**Amendments to the Drawings:**

The enclosed Submission of Formal Drawings includes changes to Figs. 14A-14E, 14H-14P, 15A, 16A, 16B, 16D, 16F, 17P-17CC (now Figs. 17O-17BB), 18B (now Fig. 18B-4), 18C, 18H, 19H, 33D and 64B.

Attachment: Annotated Sheet Showing Changes

Fig 14A

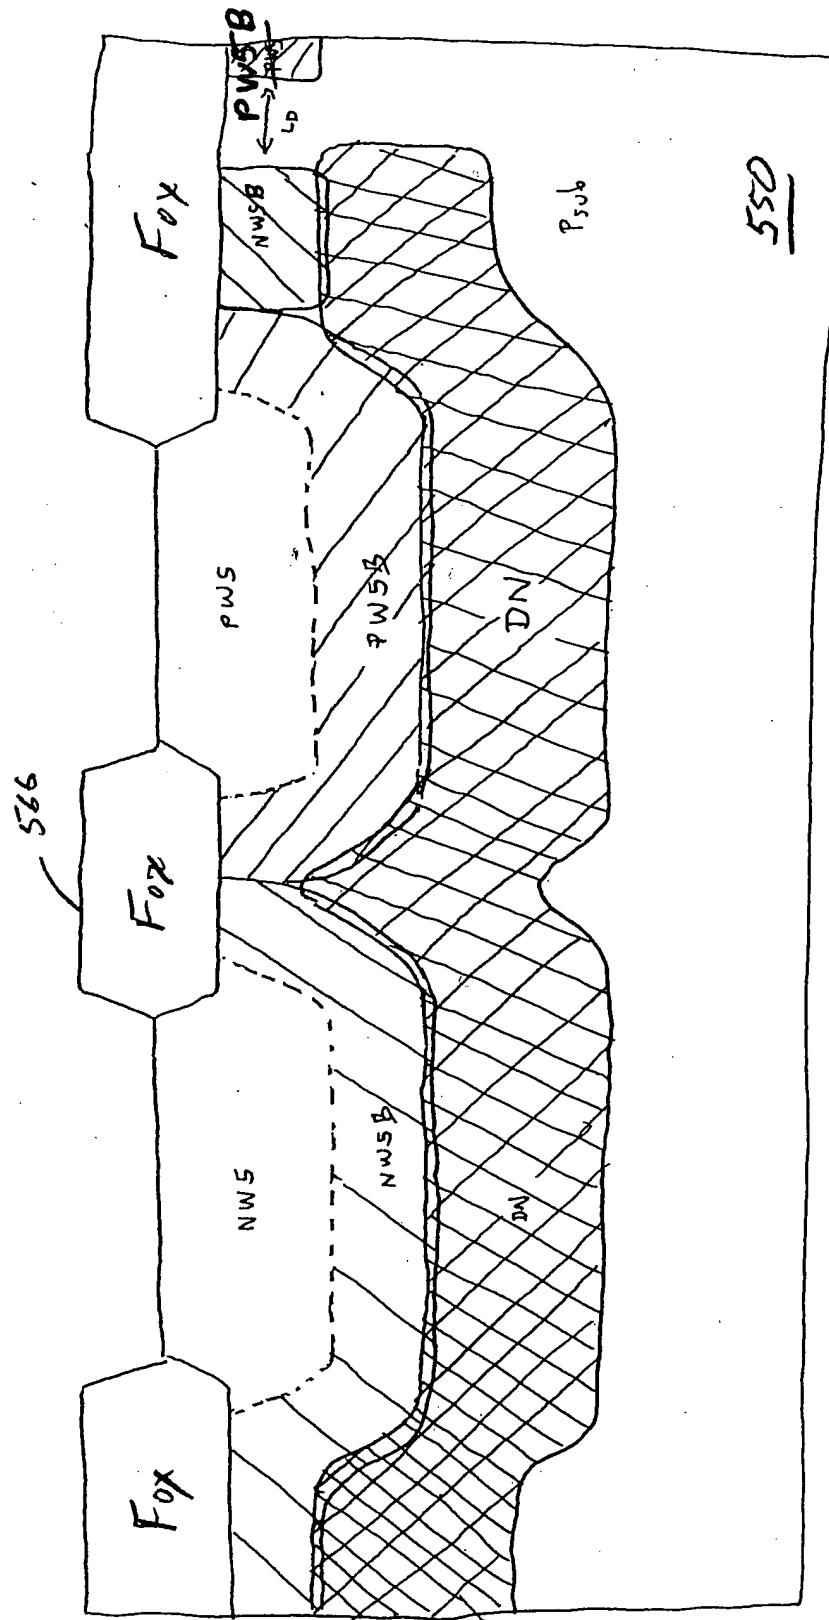
In Figs. 14A-14E, 14H-14P, 15A, 16A, 16B, 16D and 16F, in a number of instances the reference numeral PW5 has been changed to PW5B, the reference numeral NW5 has been changed to NW5B, the reference numeral PW12 has been changed to PW12B, and the reference numeral NW12 has been changed to NW12B, as shown on the enclosed Annotated Sheets. These changes are clearly supported, for example, at page 36, lines 14-17, of the substitute specification filed February 18, 2004, where it is indicated that the suffix "B" is used to denote an implanted layer of dopant as opposed to a "well" of dopant. In any event, these changes are merely changes in labeling and as such do not constitute new matter.

Fig. 18C

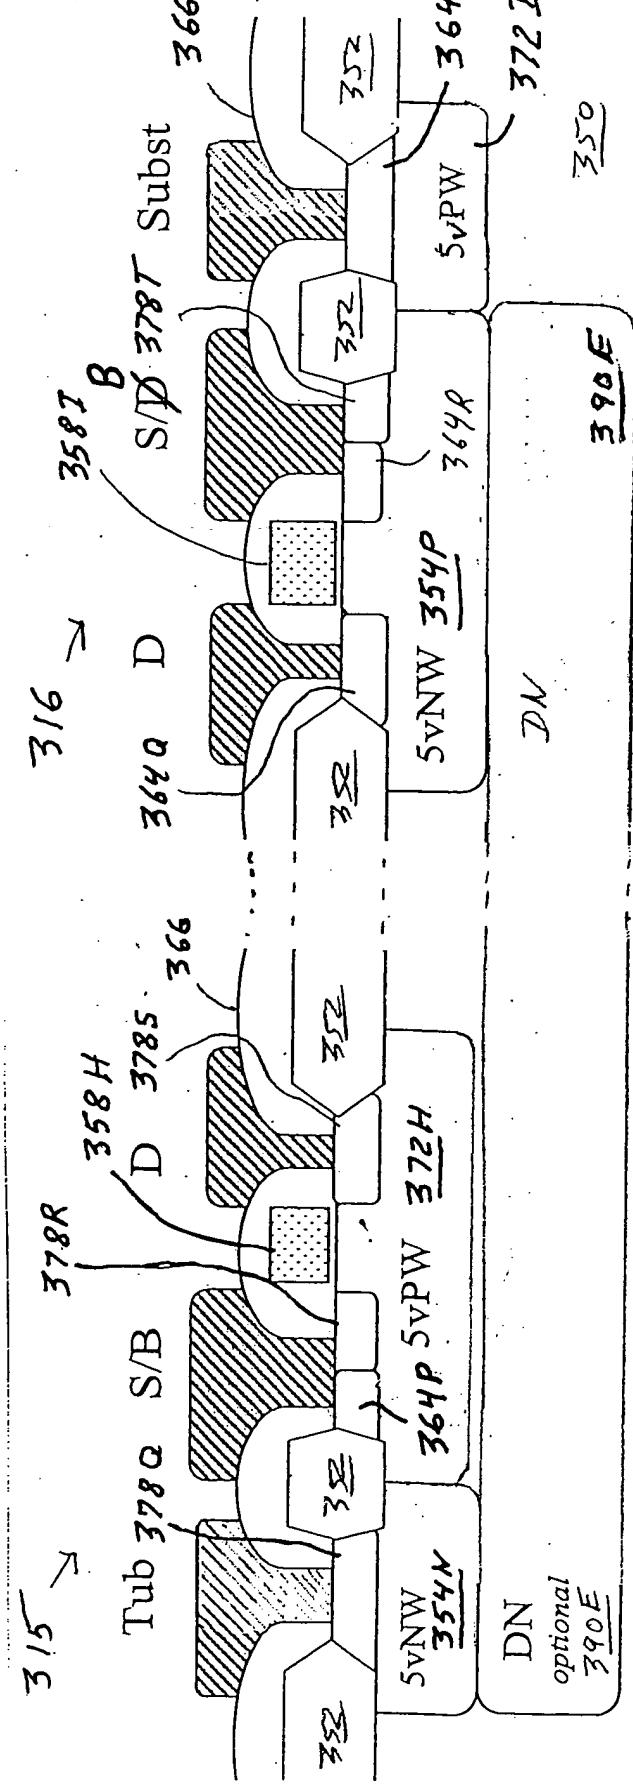
In Fig. 18C, the reference numeral 364P, which is referred to at page 66, line 4, of the substitute specification, has been added, and the designation of the source-body contact has been corrected from "S/D" to "S/B".

Interlayer Dielectric  
Fig 33D

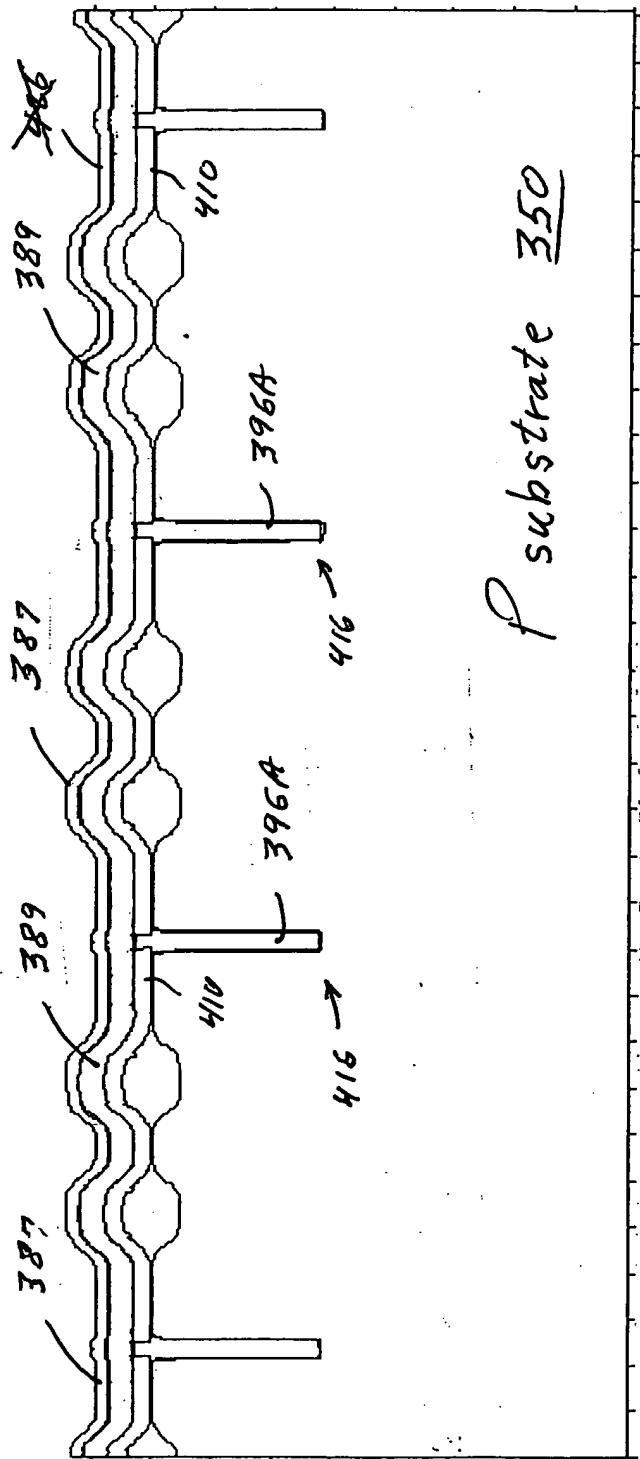
In Fig. 33D, the reference numeral 486 has been deleted. It is not referenced in the specification.

Interlayer Dielectric Deposition and Etch  
Fig. 64B

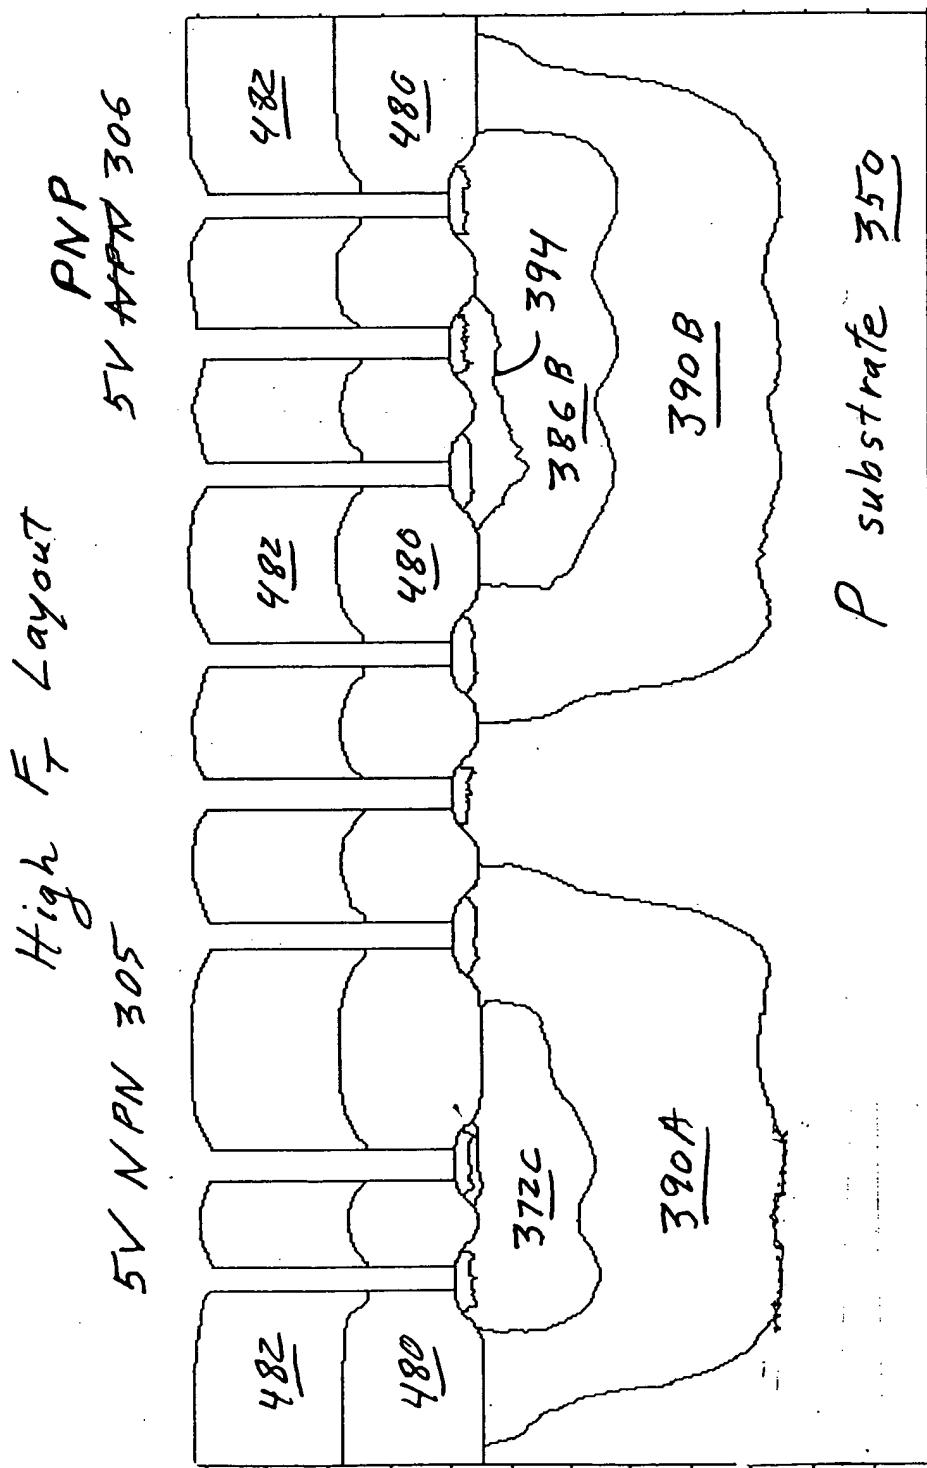
In Fig. 64B, the description of the 5 volt transistor 306 as been corrected to "PNP."

Fig. 18 H

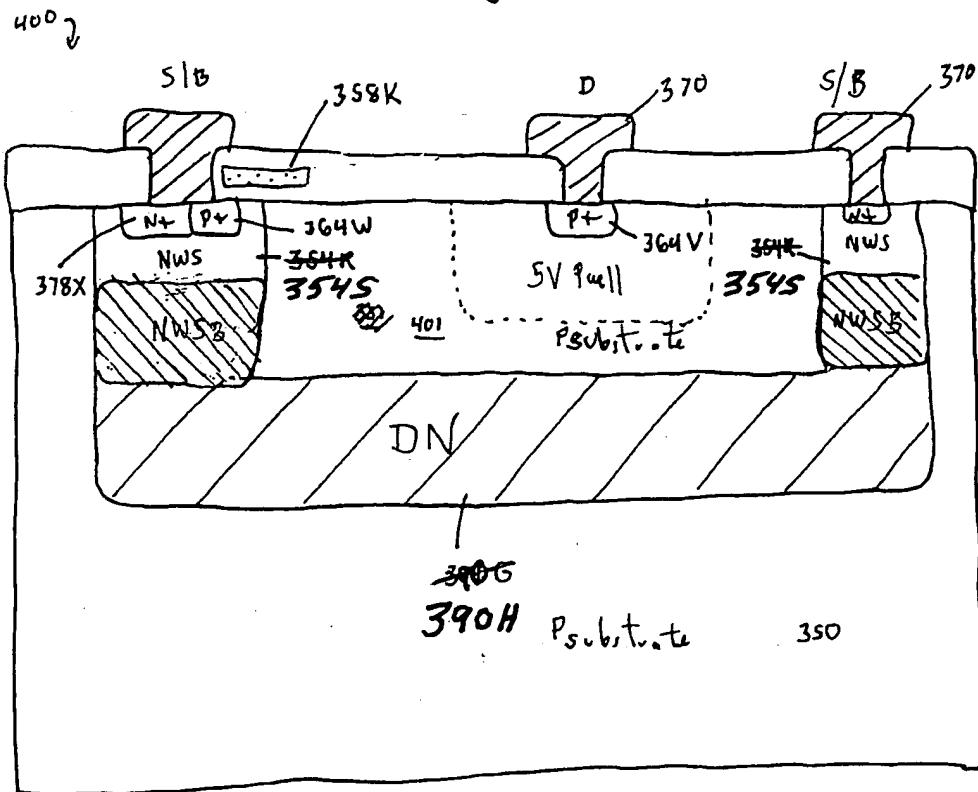
In Fig. 18H, the reference numeral applicable to the well NW5 has been changed from 354R to 354S to eliminate the conflict with the similarly numbered element in Fig.

18G; and the reference numeral applicable to the deep N layer has been changed from 390G to 390H to eliminate the conflict with the similarly numbered element in Fig. 35A.
